**EXPLANATION OF SIGNIFICANT DIFFERENCES
COMMENCEMENT BAY NEARSHORE/TIDEFLATS SUPERFUND SITE**

August 2000

D. Purpose

Figure 2A
Thea Foss Waterway Cleanup Area

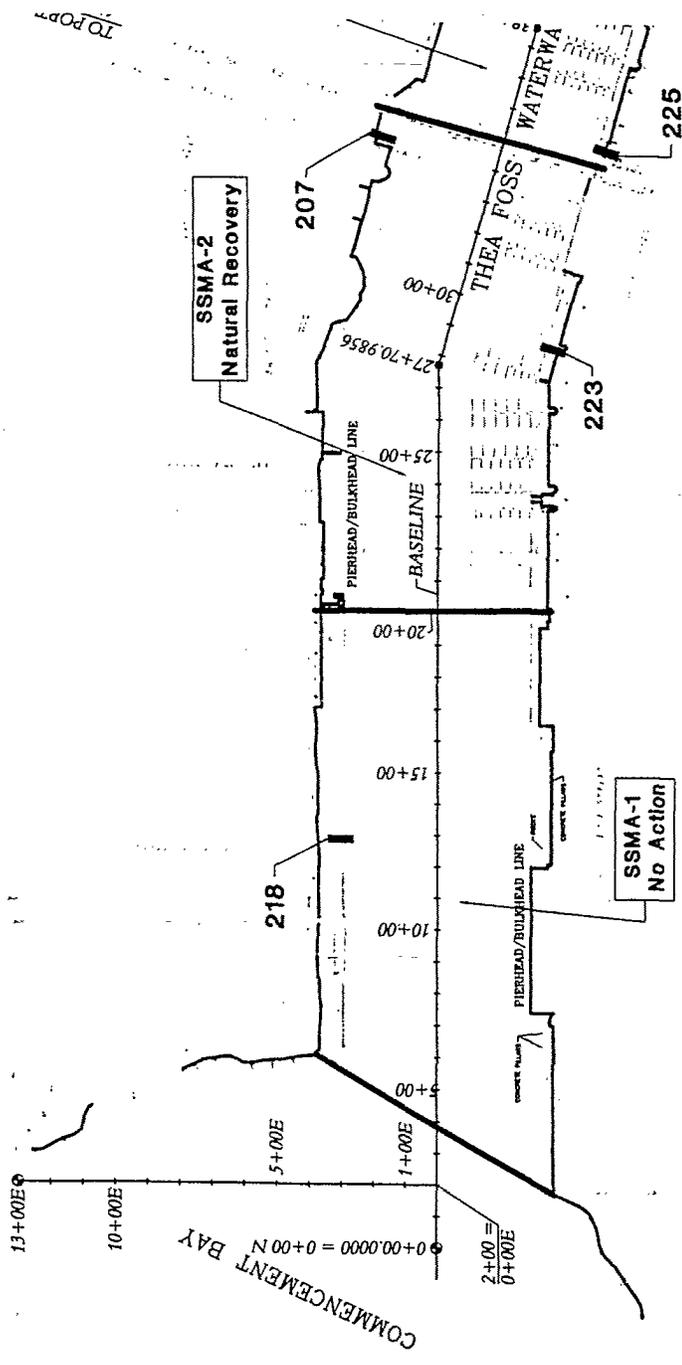
The areas within the waterways that require cleanup have been identified. The Thea Foss and Wheeler-Osgood waterways have been organized into Superfund Sediment Management Areas (SSMAs). There are seven SSMAs and they are depicted in Figure 2. The studies that have been completed indicate that the most severe contamination at surface and at depth occurs in segments 6 and 7 and tapers off gradually towards the Mouth of Thea Foss in segments 2 and 1. Primary contaminants found throughout the waterways that require cleanup both at surface and subsurface are BEP and PAHs. Other contaminants, such as metals are more localized. The head of the waterway (SSMA 7) contains deposits of NAPL beneath the sediments. This NAPL presents an ongoing source of contamination to the waterway via seeps that transport the NAPL to the surface sediments.

The majority of areas within SSMA 3 have SQO exceedances that require removal and/or capping. SSMA 3 in the navigation channel between the 11th Street Bridge and the 15th Street right of way (ROW) (SSMA 3b1, 3b2, 3b3, 3b4, 3b5a, and 3b5b) will be dredged to a specified elevation of -32 feet MLLW (elevation -30 feet MLLW with a 2-foot over dredge allowance) to remove all contaminants. Post-dredge samples will be taken to assess chemical concentrations of the dredged surface. If necessary, further dredging and/or some amount of capping may be required. Non-channel areas will undergo a combination of cleanup actions, including no action, natural recovery, capping, and dredging. SSMA 3a1 requires no action based on existing conditions. SSMA 3a2 and 3a3 are suitable for natural recovery. SSMA 3c1 will undergo a combination of cleanup actions including natural recovery, enhanced natural recovery, dredging and capping. SSMA 3c2 and 3d are areas suitable for capping.

Figure 2C
Head of Thea Foss Waterway
Cleanup Areas

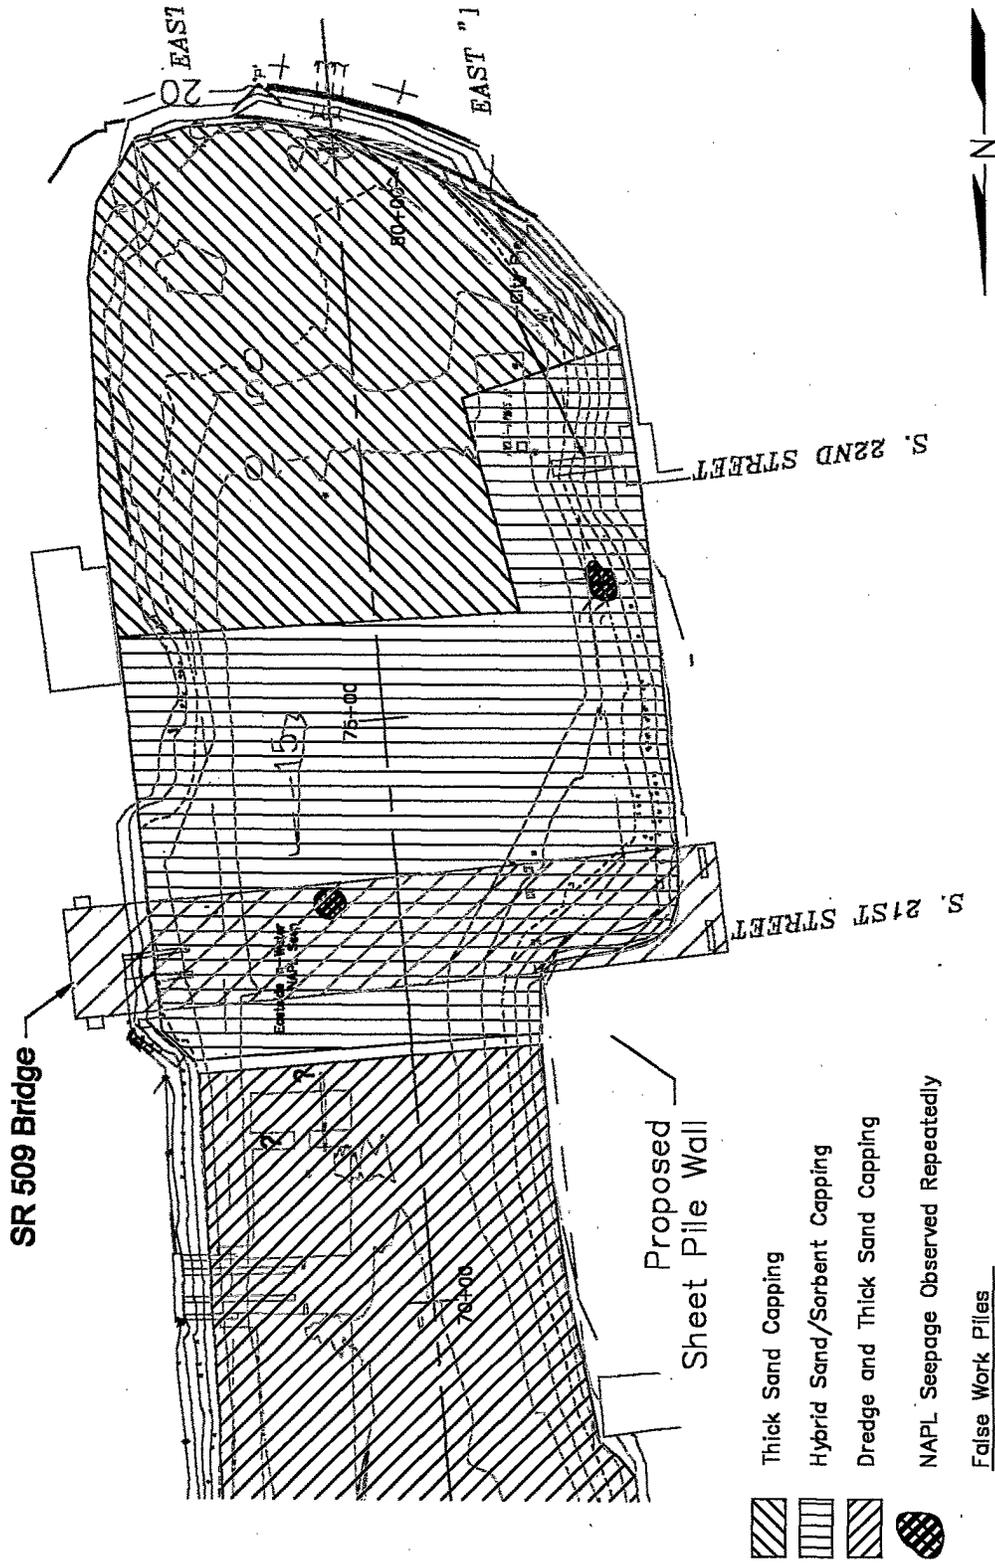
In the “Round 3 Data Evaluation and Pre-Design Evaluation Report, Appendix U,” the City of Tacoma recommended a specific in-water remedial action for the head of the Thea Foss Waterway to address the in-water NAPL contamination and seeps. Based on a subsequent technical memorandum, (Technical Memorandum from Hart Crowser to Mary Henley, City of Tacoma, dated June 14, 2000) the City of Tacoma modified their recommended approach.

The City’s modified approach for remediation is acceptable to EPA. In the design phase and prior to remedial action, however, the following specific performance criteria for source control and the remedy for the head of the waterway must be met to eliminate or reduce the potential for

- 1) An approved stormwater action plan which includes, at a minimum, the following:
 - a) an Ecology-approved stormwater sampling and analysis plan which will complete the Stormwater Management Plan for Thea Foss as required under the general NPDES permit,
 - b) a phthalate study for determining possible phthalate sources to the Waterway,
 - c) pilot testing to determine the contribution of dissolved versus particulate contaminant loading to the Waterway,
 - d) an evaluation of stormwater structural controls, and
 - e) an implementation schedule for the above stormwater studies, plans and controls.

EPA will require additional source removal and/or modification of the cap design if these performance criteria cannot be met by the City's remedial design and implementation.

Figure 3A
Hylebos Waterway Cleanup Areas

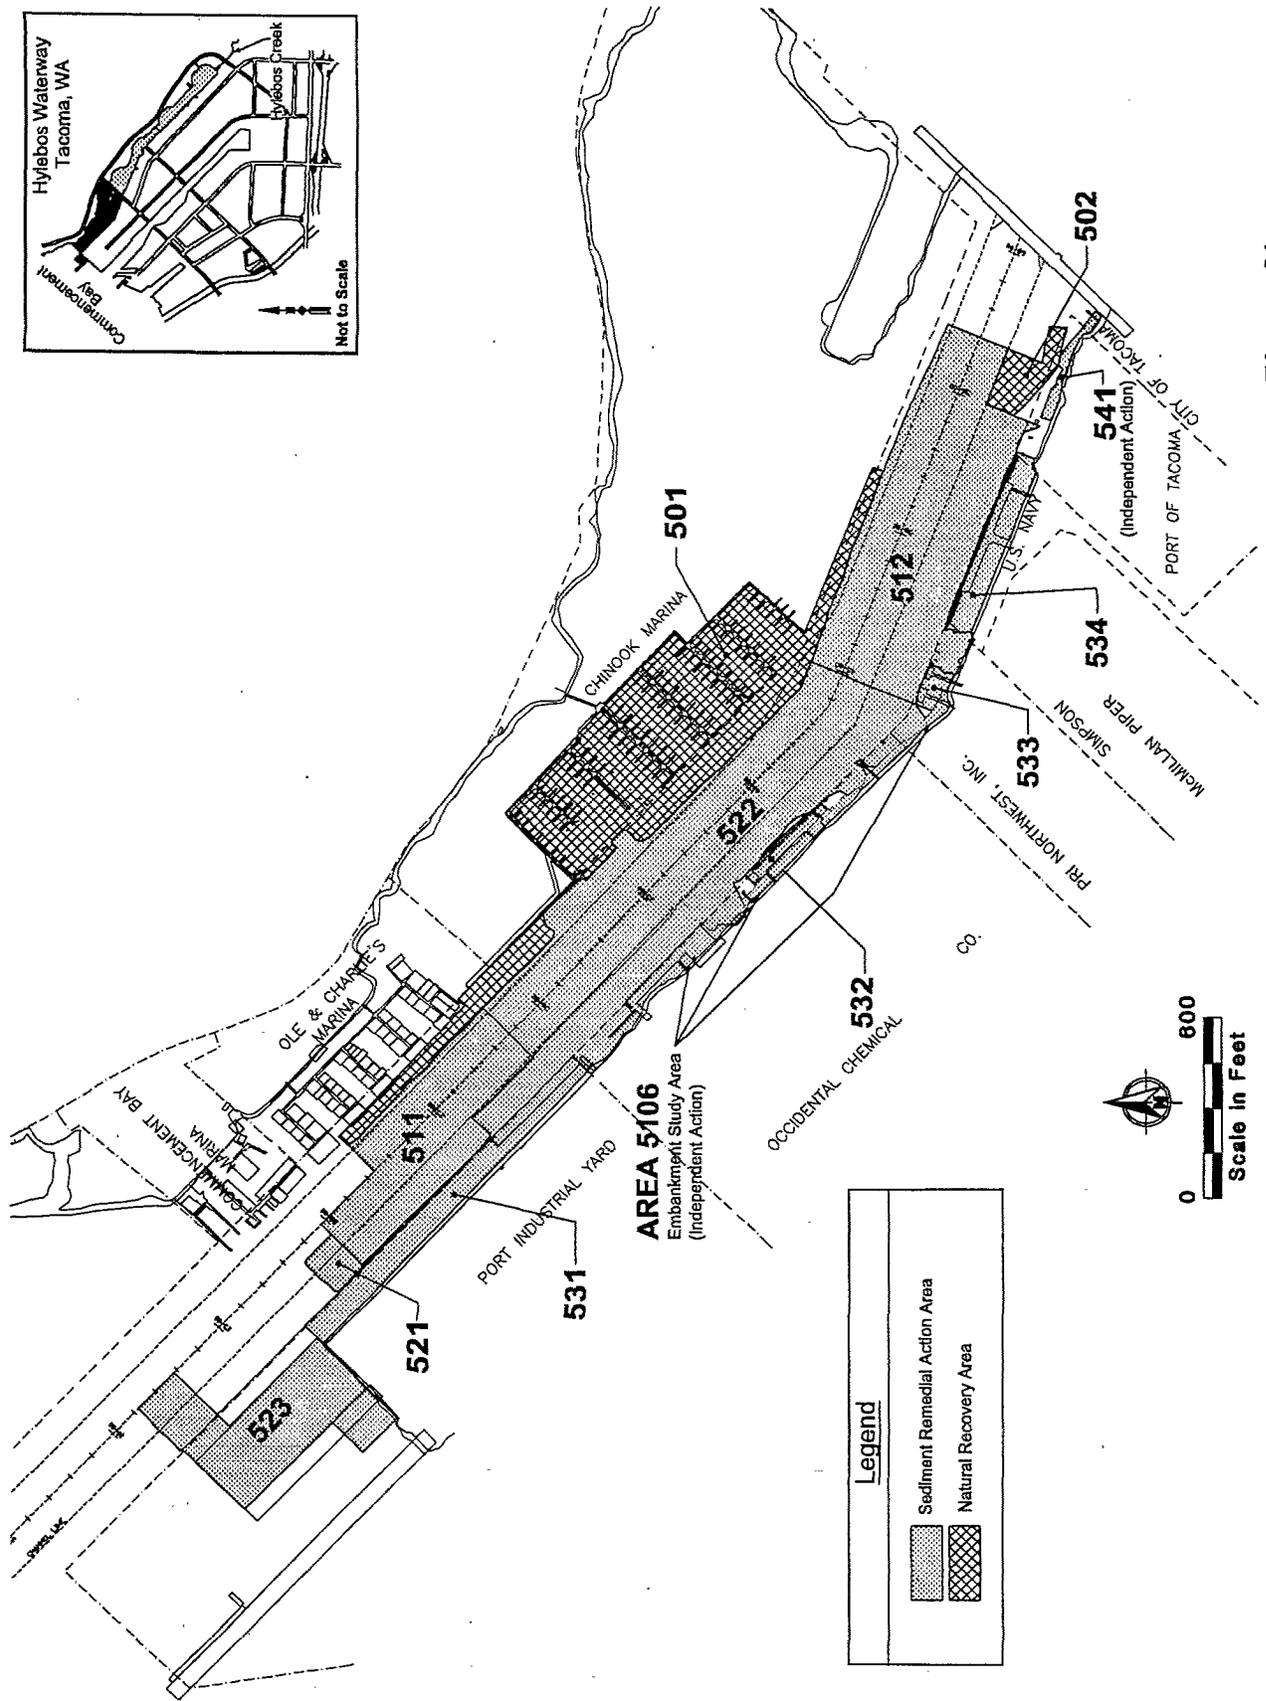
in the Hylebos Waterway, and proposed disposal sites for dredged sediments. The proposed cleanup plan is shown in Figures 3a-c, and is described in more detail in the report.

As shown in Figure 3a, most of the waterway north of the 11th Street Bridge is to be dredged under the cleanup plan. The area in front of Ole and Charlie's Marina (Sediment Management Area, "SMA" 511), within and in front of the Chinook Marina (SMA 501), and a small area near the 11th Street Bridge (SMA 502) contain only low-level contamination and will be monitored as natural recovery areas.

The cleanup areas shown in Figures 3a-c represent a preliminary cleanup plan, with specific dredged material management areas and volumes to be finalized and approved by EPA in remedial design.

Figure 3B
Hylebos Waterway Cleanup Areas

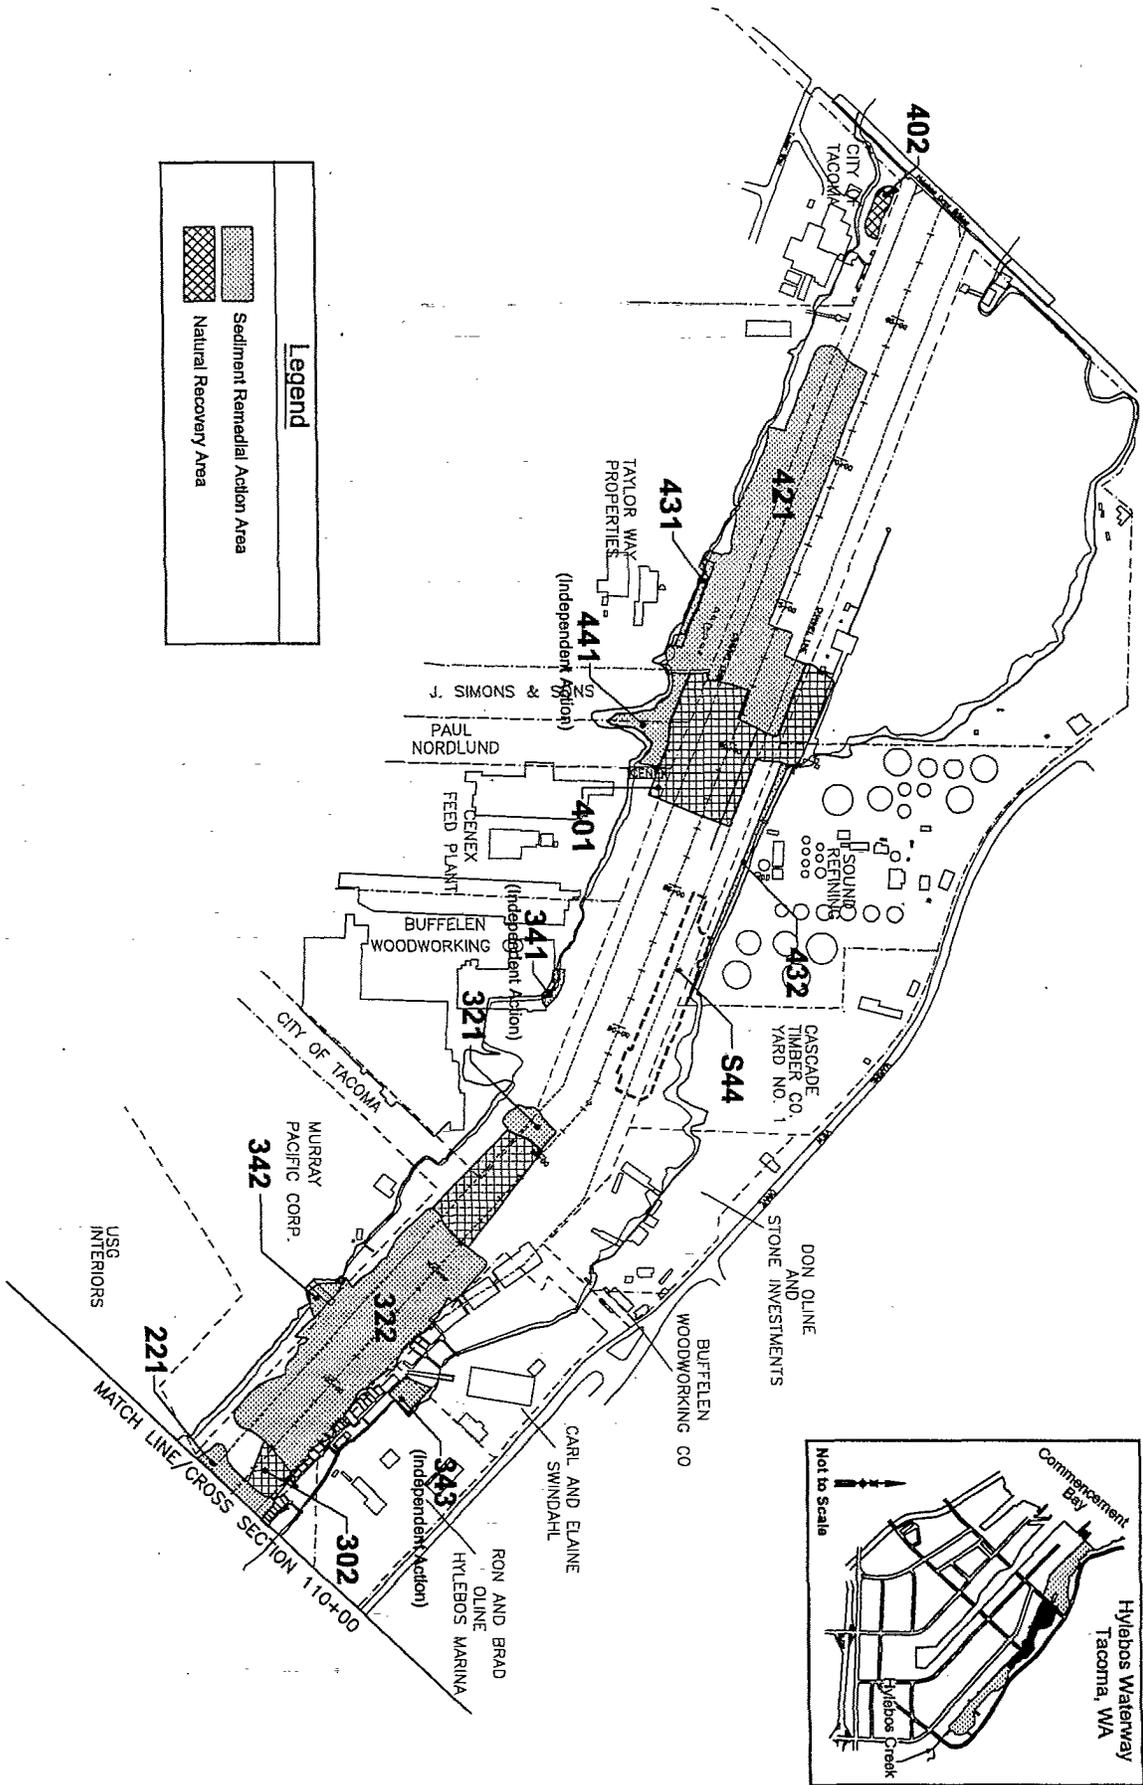
Figures 3a-c also show intertidal areas that require cleanup. The plan presented in the Pre-remedial Design Evaluation Report is for 11.6 areas under dock/structures and isolated intertidal areas to be capped. However, whether intertidal areas will be dredged or capped will be reevaluated in the design phase on a property by property basis, taking into account factors such as:

Figure 3C
Hylebos Waterway Cleanup Areas

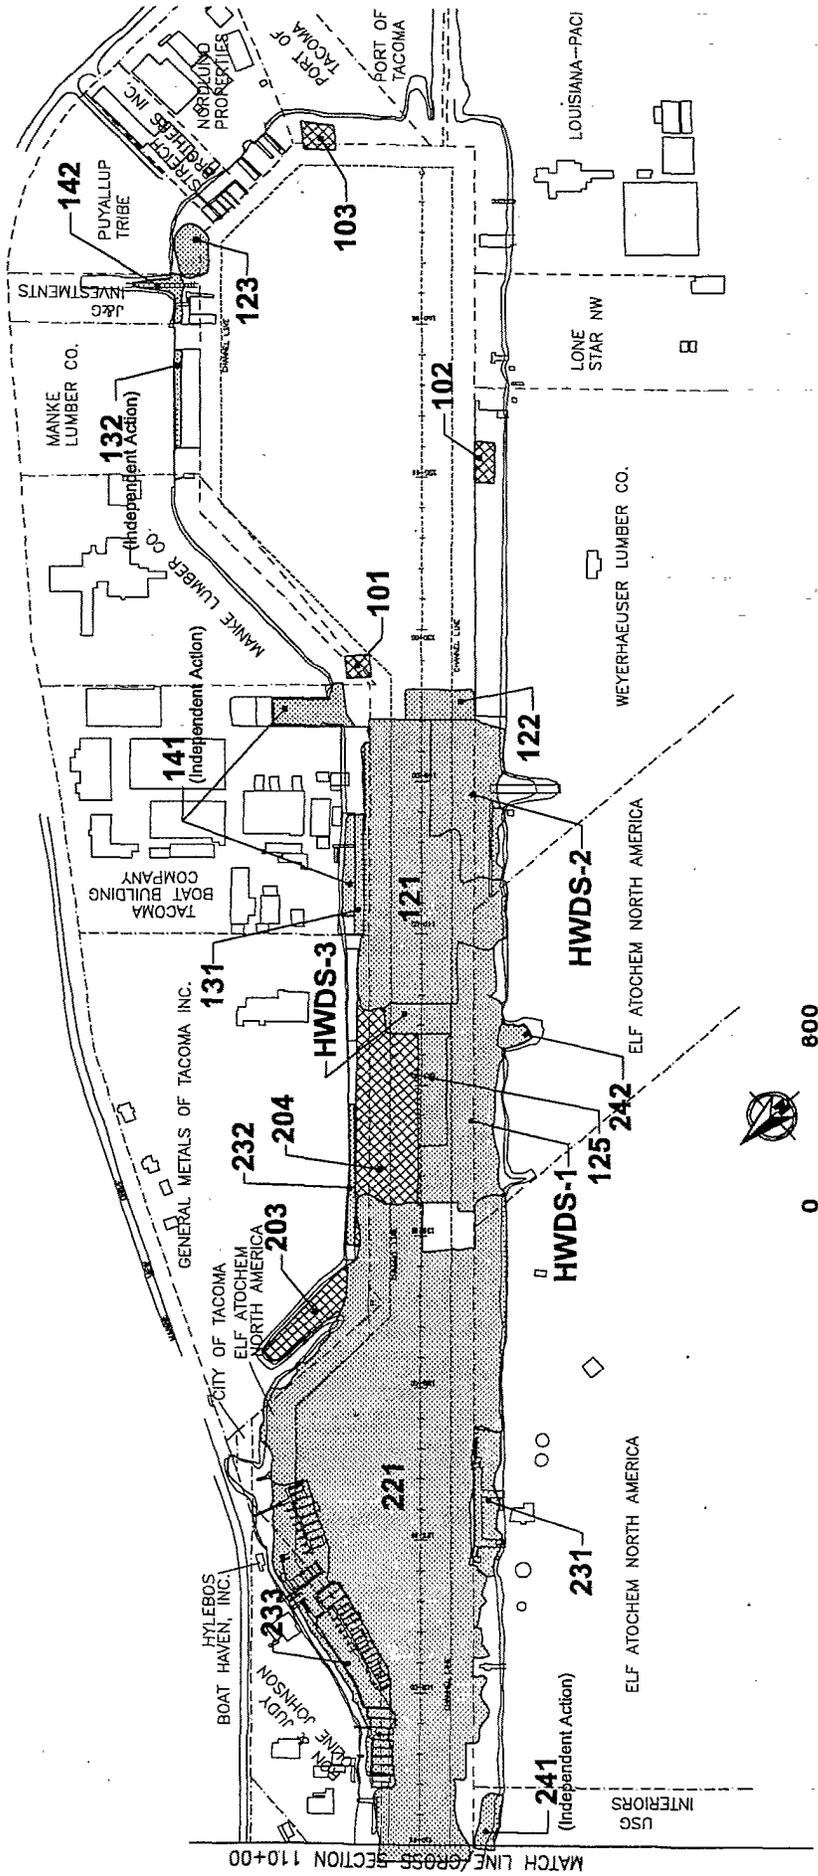
Some intertidal cleanup actions have been addressed by individual property owners working with Ecology. Those intertidal cleanups where EPA has approved the final cleanup will not require remediation as part of the overall waterway cleanup. EPA will, however, determine whether long-term monitoring is needed at these properties as part of the waterway design process. To date, EPA has approved the intertidal cleanups at SMA 232 at General Metals of Tacoma and SMA 241 at the former USG Interiors facility (see Figure 3-c).
